DRAINAGE AND TRANSPORTATION INFORMATION SHEET

Project Title: THE GEORGE **Building Permit #** **Hydrology File #**

RE: 170 Central Ave.- The George

I have reviewed your comments provided on August 10, 2023 and have provided responses to your comments below.

TCL01

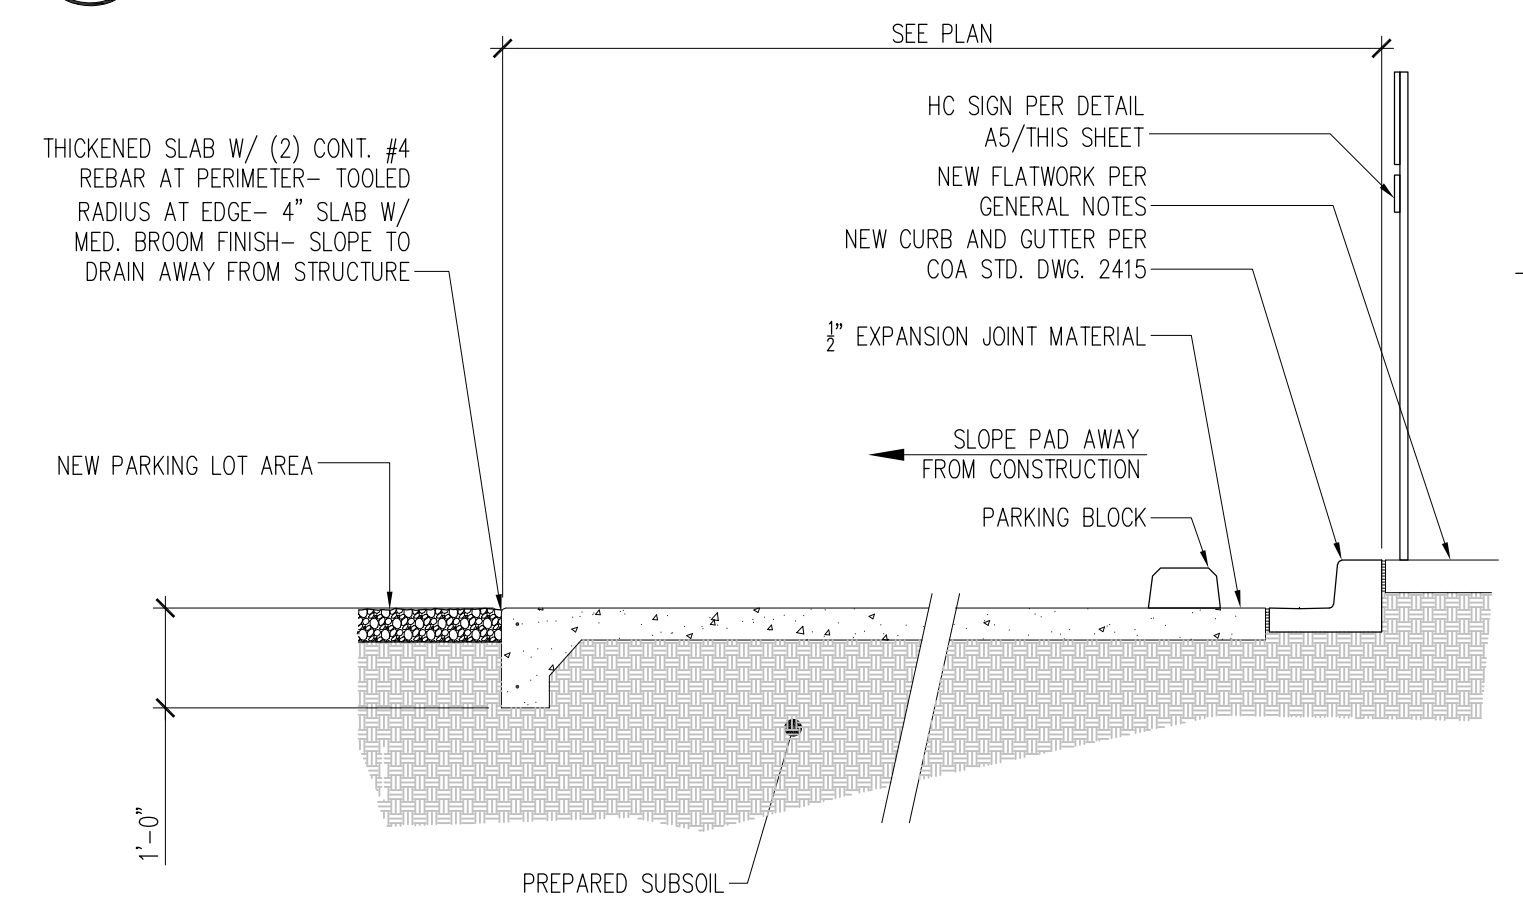
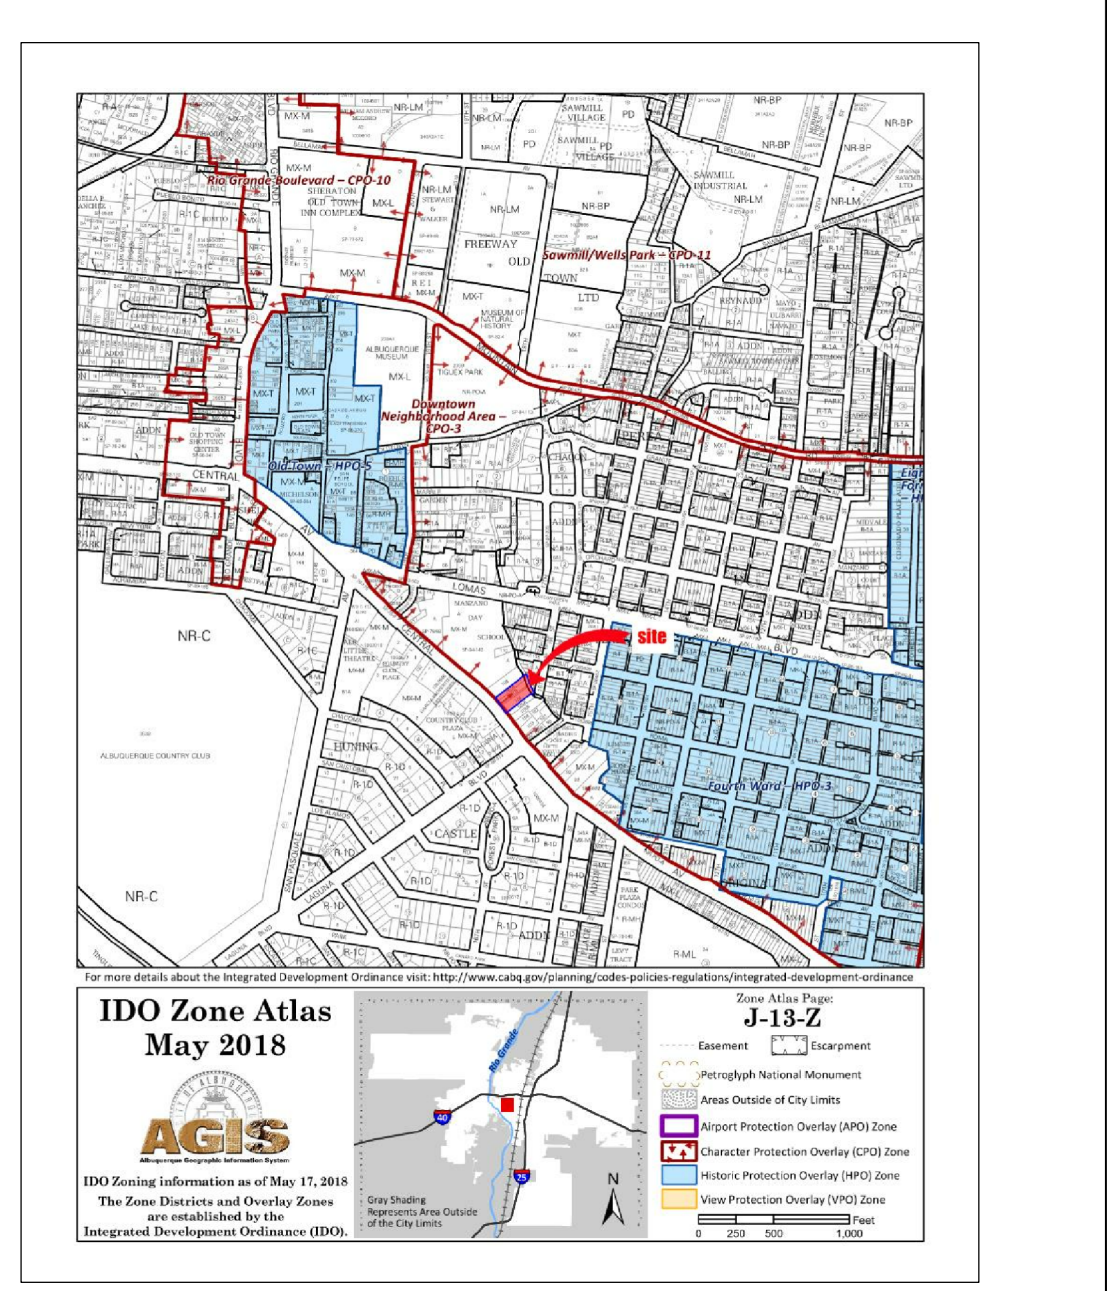
1. Please show on the site plan the north direction to determine the orientation of the site.
Response: North arrow has been added.
2. Identify all existing access easements and right of way widths.

Response: Right-of-way widths and road widths have been added for your use.
3. Identify the right-of-way widths medians curb cuts and street widths on central and 16th St.

6. Keyed note 18: Please reference COA STD DWG 2430. It appears that there is a water meter in the public sidewalk by the construction area off Central. Please contact Water Authority for a permit.

7. Please define keyed note #29.

9. Show the clear site triangle and the following note to the plan: "Landscaping and signage will not interfere with clear sight requirements. Therefore, signs, walls, trees, and shrubbery between 3 and 8 feet tall (as measured from the gutter pan) will not be acceptable in the clear sight triangle.

11. Add a note stating "All broken or cracked sidewalk must be replaced with sidewalk and curb & gutter." A build note must be provided referring to the appropriate City Standard drawing.

Response: Information has been added as requested. See also response #2.
4. Shared Parking Agreement must be approved and signed by director Alan Varela and City authorized notary.

Response: Keyed note #18 has been revised to include reference to COA standard detail 2430. Note this is also referenced in the general notes. Water Meter will be relocated and permitted at time of construction.

Response: Keyed note #29 has been removed from the drawing.

Response: The note is included in the TCL General Notes Sheet TCL01.

Response: This note is included in the TCL General Notes sheet TCL1.

SITE PLAN:
 REFUSE
 AS110.1

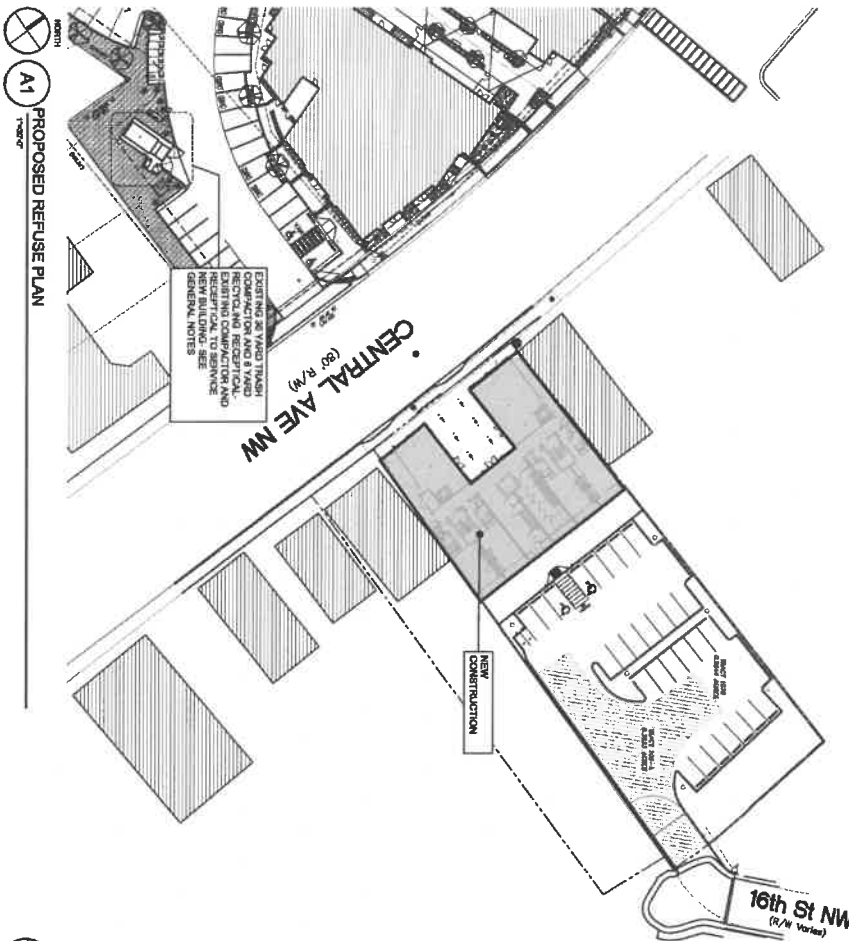
8. Refuse vehicle maneuvering shall be contained on-site. The refuse vehicle shall not back into the public right of way. provide a copy of refuse approval.

Response: See attached for approved Refuse plan
